APPEAL SUMMARY

Appeal ID: 23789	Project Address: 3800 SE 164th Ave
Hearing Date: 6/10/20	Appellant Name: Hayley Purdy
Case No.: B-002	Appellant Phone: 503-896-5341
Appeal Type: Building	Plans Examiner/Inspector: Alice Johnson, Thomas Ng
Project Type: commercial	Stories: 3 Occupancy: R-2 Construction Type: V-B
Building/Business Name: Centennial Place Apartments	Fire Sprinklers: Yes - Throughout
Appeal Involves: Erection of a new structure	LUR or Permit Application No.: EA #19-201053
Plan Submitted Option: pdf [File 1] [File 2] [File 3] [File 4] [File 5]	Proposed use: Multi-family

CENTENNIAL PLACE APARTMENTS

1 COMMUNITY RM CEILING PLAN
1/4" = 1'-0"

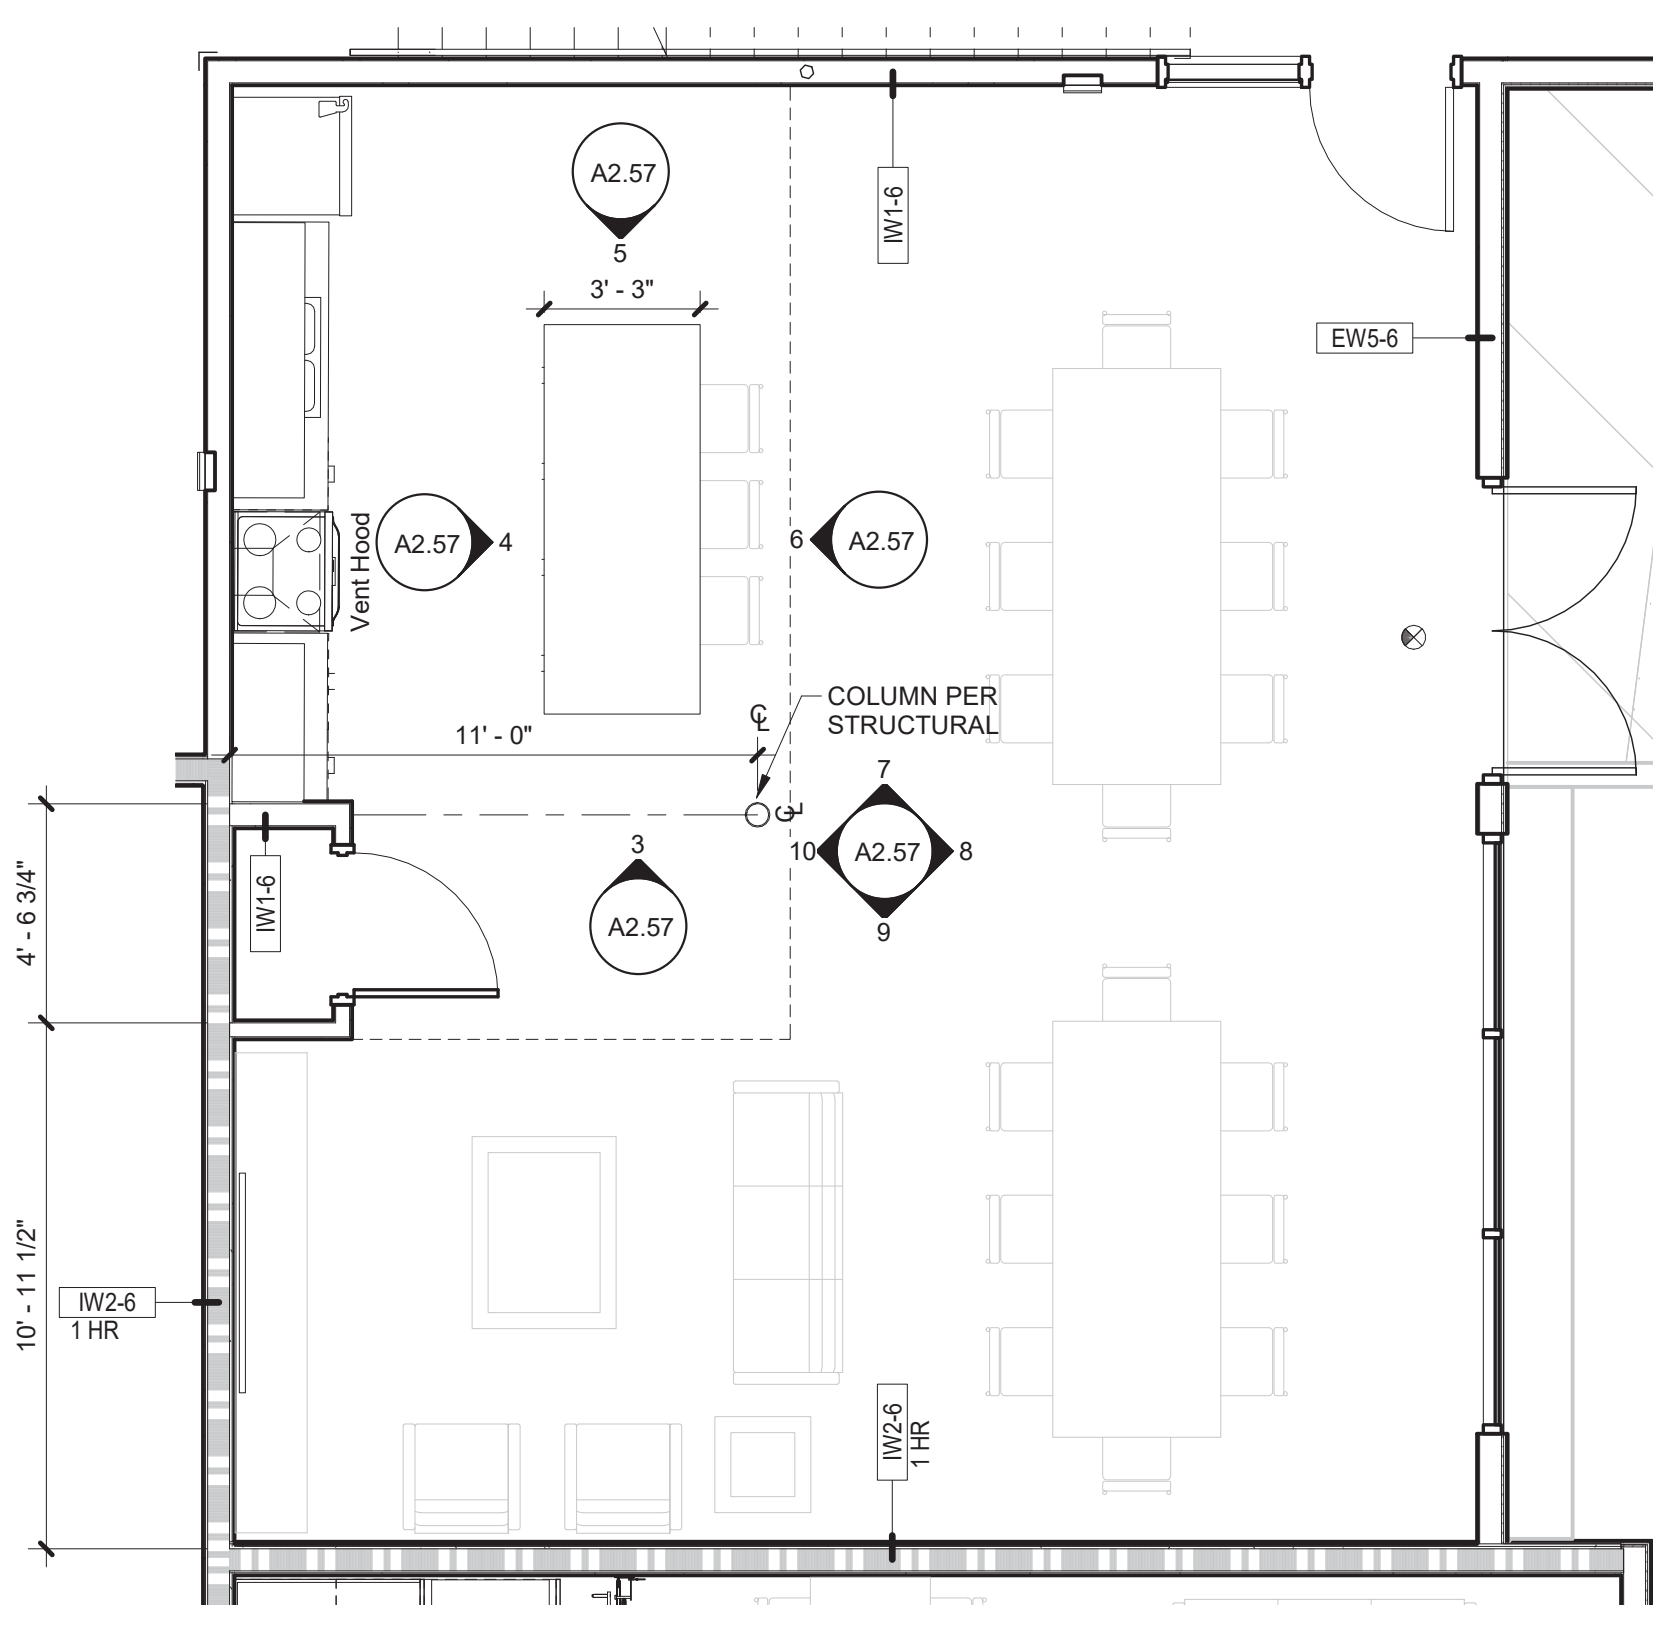
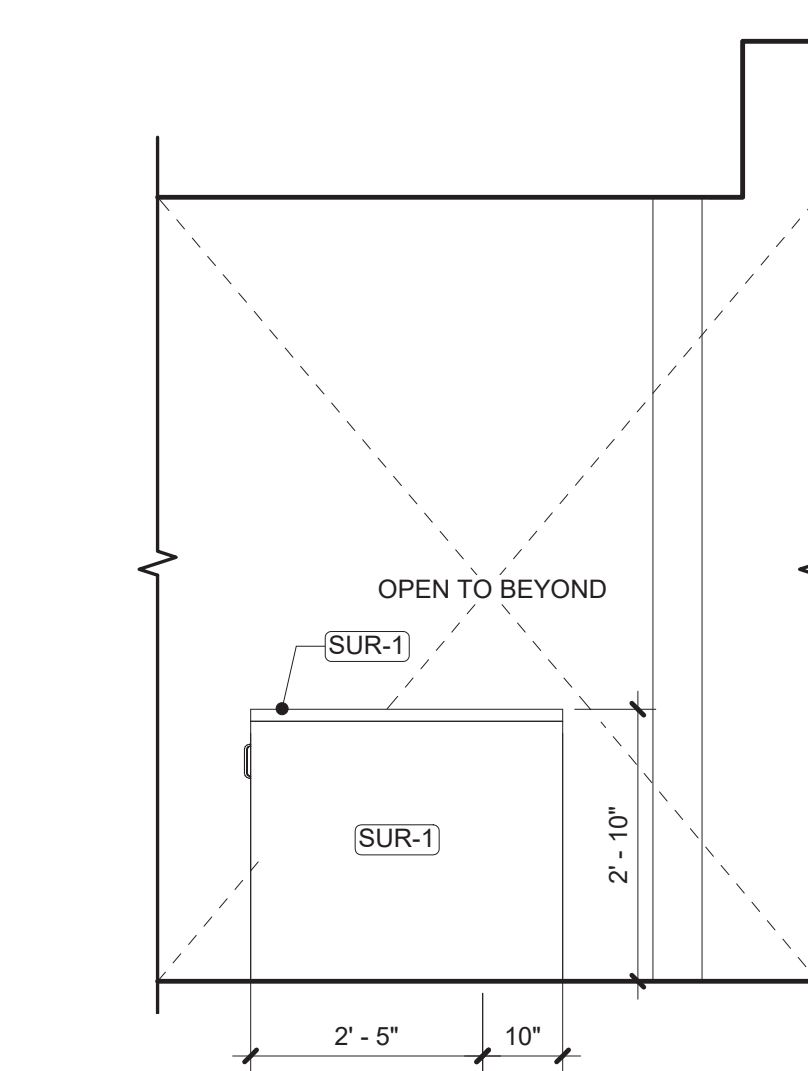
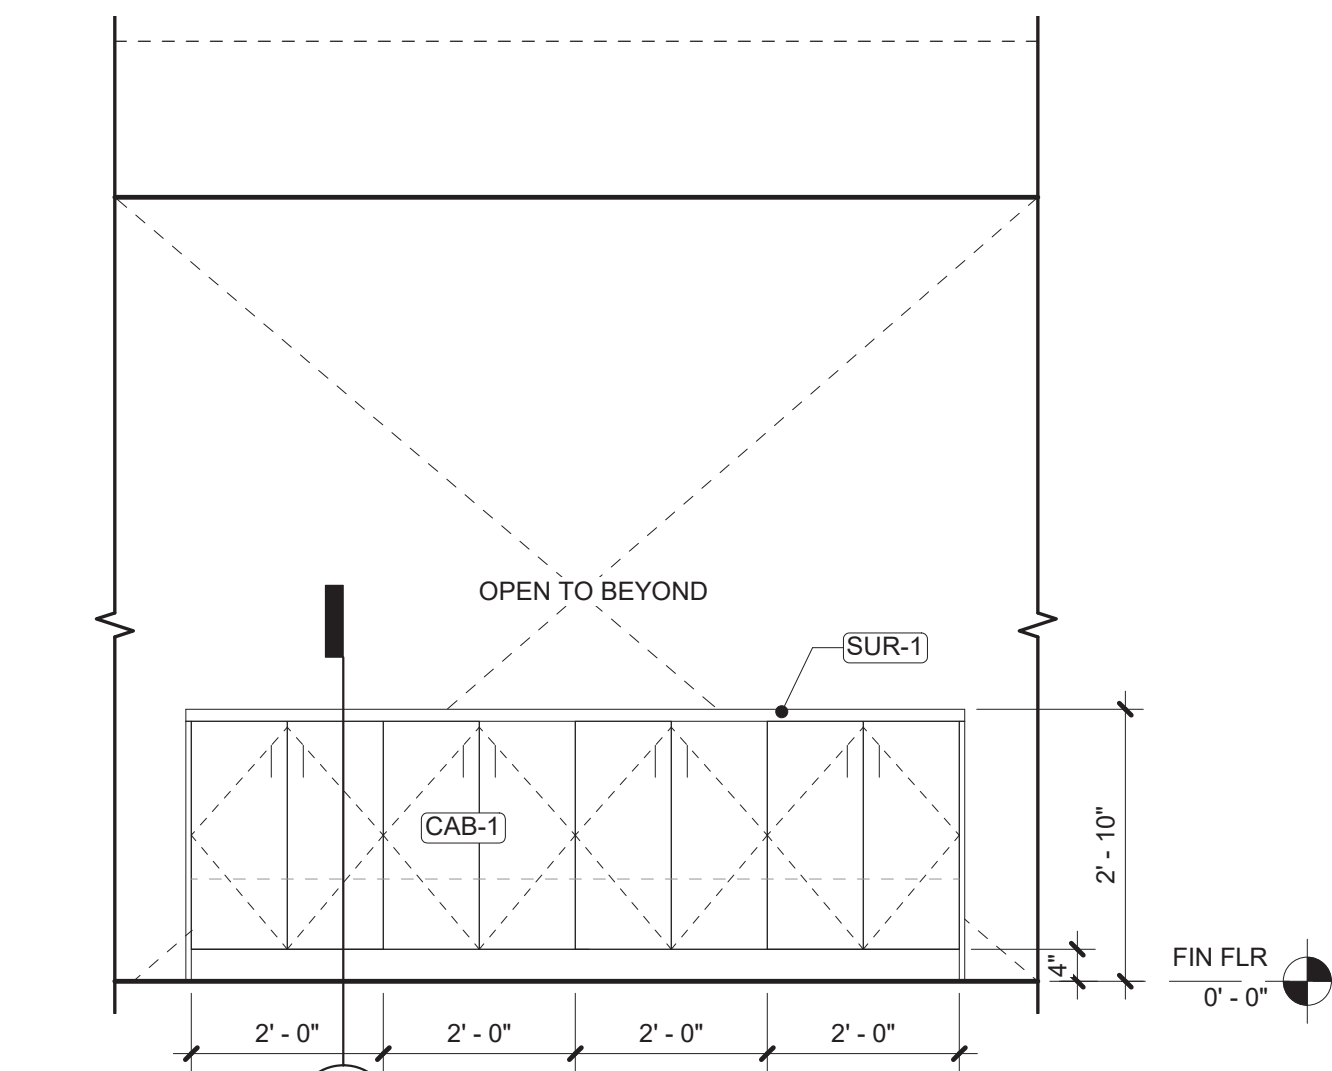
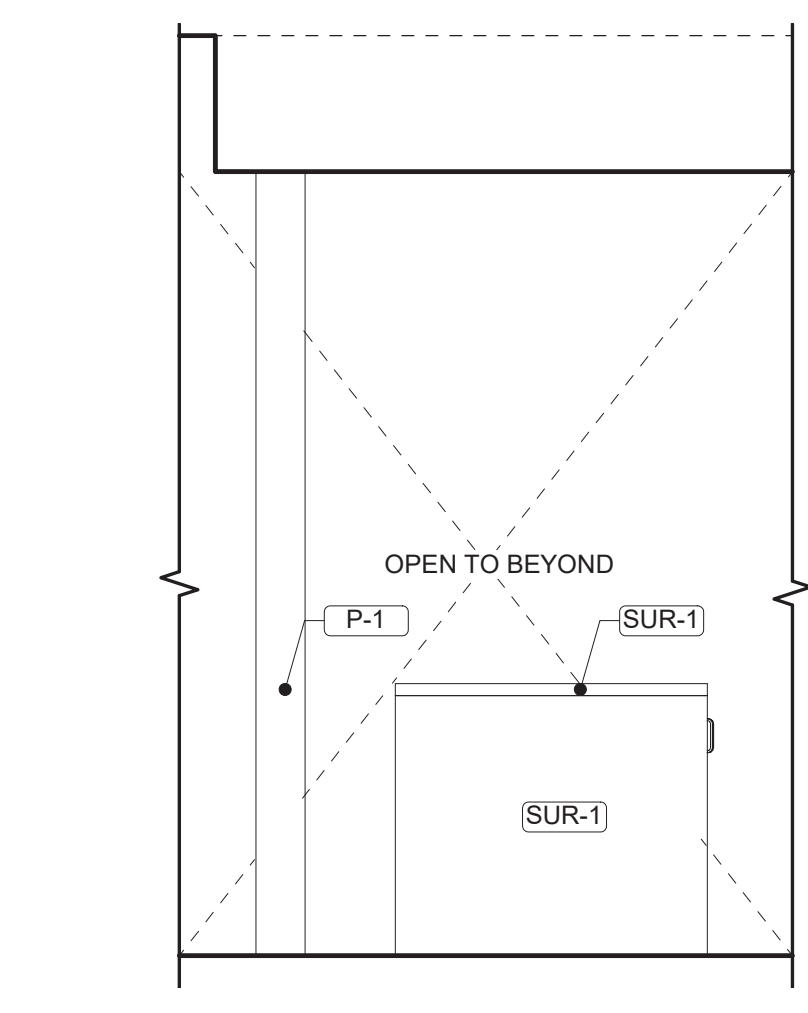
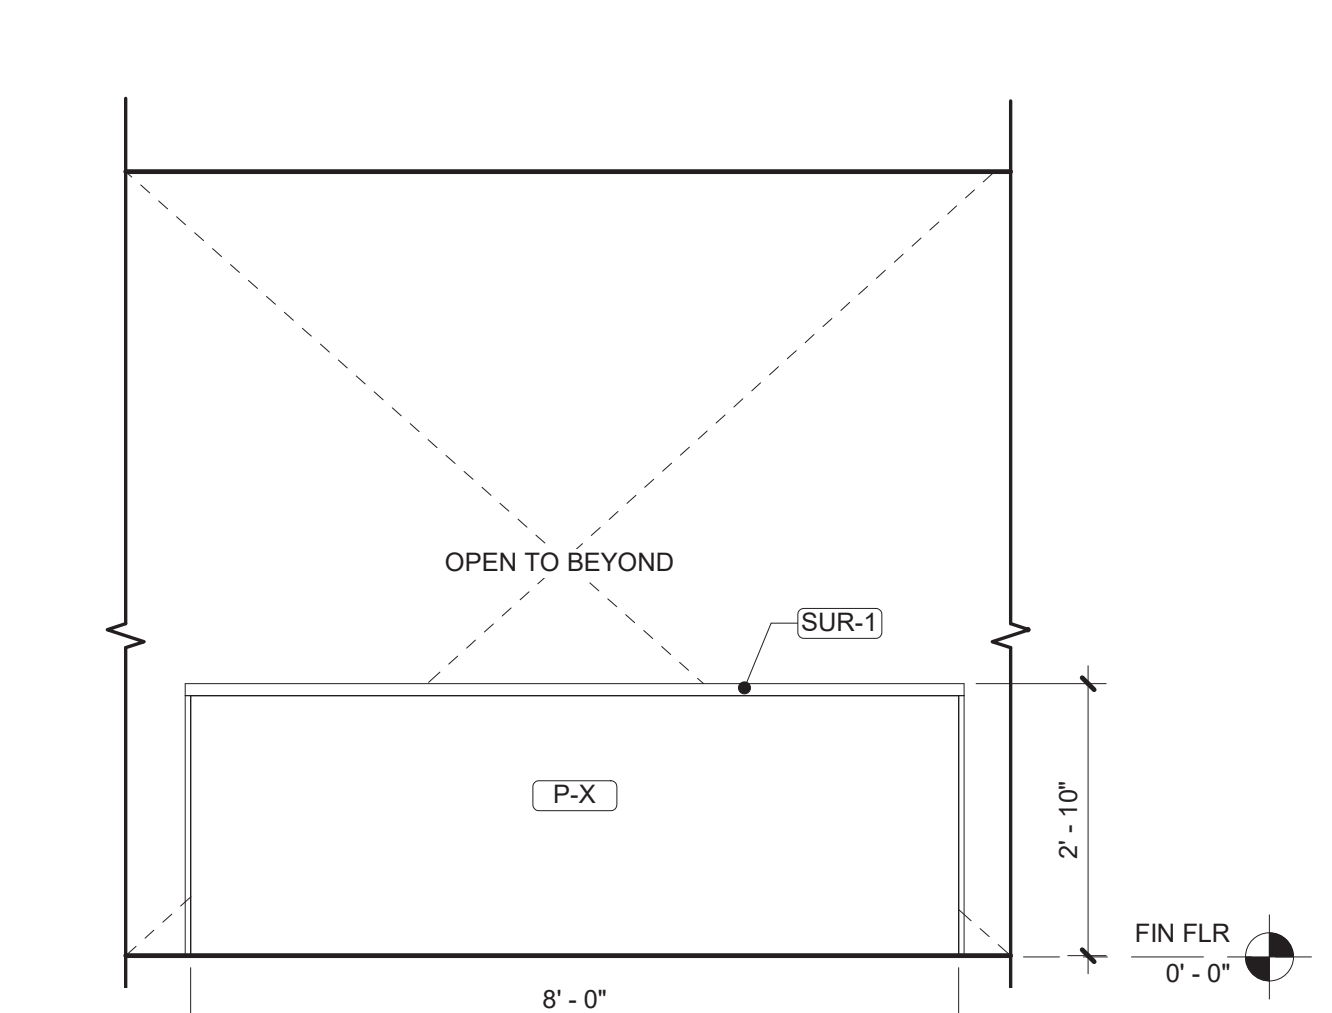
Code Section	19 OFC 607.2, 19 OMSC 507.1.2
Requires	IFC 610.2: A Type I hood shall be installed at or above all commercial cooking appliances and domestic cooking appliances used for commercial purposes that produce grease vapors. IMC 507.2: Type I hoods shall be installed where cooking appliances produce grease or smoke, such as occurs with griddles, fryers, broilers, ovens, ranges and wok ranges.
Code Modification or Alternate Requested	Provide a Type II Hood above the residential range in the first floor Community Room kitchen, Room 108.
Proposed Design	Applicant proposes to use a Type II hood above a residential range. The proposed design is a Type II hood serving one domestic electric range. The hood will be installed with manufacturer's recommended ducting to the exterior of the building. A sprinkler heads will be located within 6 feet of the range and hood or as directed by the Fire Marshal's Office. Portable fire extinguishing equipment shall be provided as directed by the Fire Marshal's Office. A sign will be provided stating "NO FRYING, GRILLING, SAUTÉING OR GREASE PRODUCING COOKING ALLOWED ON THIS INSTALLATION".

Reason for alternative	The project is a 71 unit apartment project with each unit having a full kitchen. The 1st floor community room is small, with an occupant load of 49. The community room will be available to residents and their guests only, this space will be used much the same as a single-family residential kitchen/living room/dining room and is actually much smaller than most of these types of spaces. The proposed kitchen will not be the primary source of meals, therefore not used with the intensity of a commercial kitchen. Appeals for Type II hoods have been previously granted.

1. Use of commercial range with Type II hood in 2nd floor multi-purpose room: Granted provided:

- 1.) Grease producing cooking is prohibited.
- 2.) A permanent etched sign shall be installed in plain sight on the hood stating "NO FRYING, GRILLING, SAUTÉING OR GREASE PRODUCING COOKING ALLOWED ON THIS INSTALLATION".
- 3.) Portable fire extinguishing equipment shall be provided as directed by the District Fire inspector.
- 4.) The District Fire inspector shall have the authority to summarily void this approval if any of the above conditions are violated.
